SRRTEP COMMITTEE: MID-ATLANTIC PSE&G SUPPLEMENTAL PROJECTS

PSE&G Supplemental Project S2537 Cost Update

Supplemental Project ID: s2537 (received in 2021)

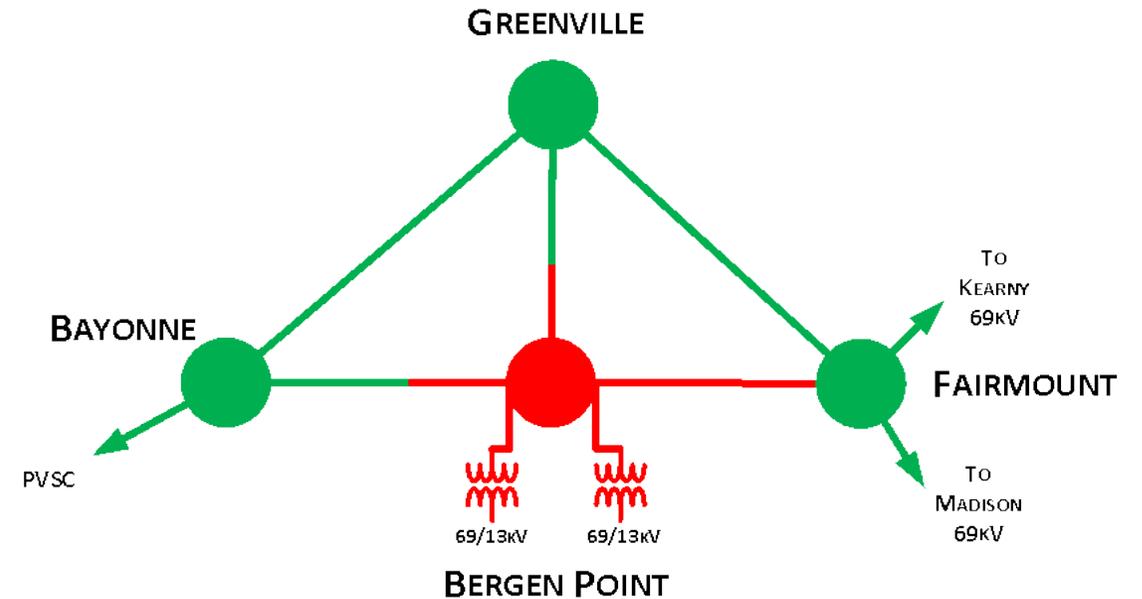
- Still on track to construct a new 69/13kV substation in the Bergen Neck Area to feed Bergen Point load and provide for future load growth.
- Environmental challenges have necessitated changing the proposed location of the 69/13kV substation from the initial new property to the existing space-constrained Bergen Point substation, which will require acquisition of additional adjacent properties.

- Configuration of solution remains the same. Modifications to solution include:
 - Construct 69kV ring bus Class H at Bergen Point site and adjacent properties with two (2) 69/13kV transformers and three 69kV lines.

- Constructing at existing substation and adjacent properties requires building GIS as opposed to AIS.
 - Construct a primarily underground 69kV network between Greenville, Bayonne, Fairmount, and the existing Bergen Point site (adds approximately 4 miles of underground construction).

- Equipment and construction costs have substantially increased since the project was brought forward in 2020.
 - **Estimated Cost: ~~\$116M~~ \$161M**
